NUCLEAR REGULATORY COMMISSION

Title: Advisory Committee on Reactor Safeguards
 Subcommittee on AP1000 - Open Session

Date: Tuesday, February 2, 2010

OI 2: Water Tank Missile

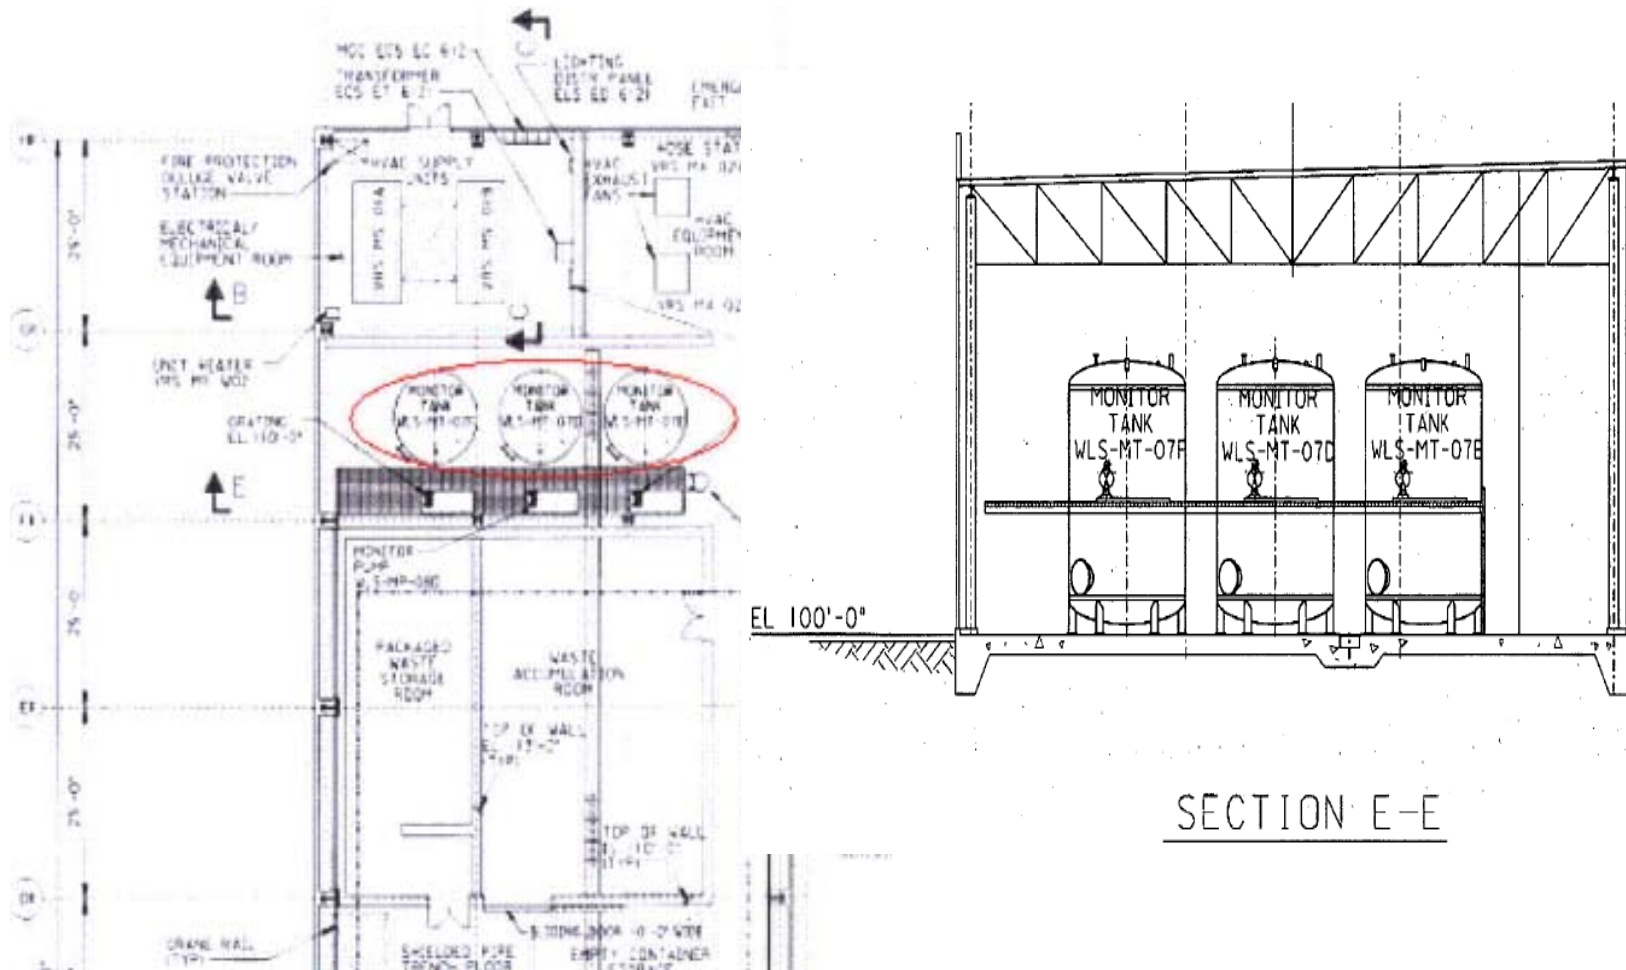
11 Open item number two addresses another
12 missile type. This is water tank similar to the
13 automobiles -- missiles from the parking lot. Here is
14 a sketch of the radwaste building. On the left side
15 is an engineer's drawing or a plan and on the right
16 hand side is the conception of the front view. As you
17 can see there are three additional water tanks each
18 with 105,000 pounds of water in there. So once the
19 building collapsed due to the impact, and those tanks
20 were set free and move just like an automobile.
21 Remember the mass of this water tank is ten times
22 heavier than a typical 3,000 pound automobile. So it
23 considers the global impact on the Category 1
24 building, and we need to make sure that this impact
25 will not compromise the buildings.

OI 2: Water tanks in radwaste building needs to be evaluated as a potential wind-borne missile against seismic category I structures.

This analysis is pending in the DCD as open item OI-RAI-SRP3.3.2-SEB1-02.

14 MR. CHUANG: Yes, but there is no
15 requirement. If they can provide the analysis to show
16 the angle of support underneath can strongly support
17 it from moving out, then it's okay.
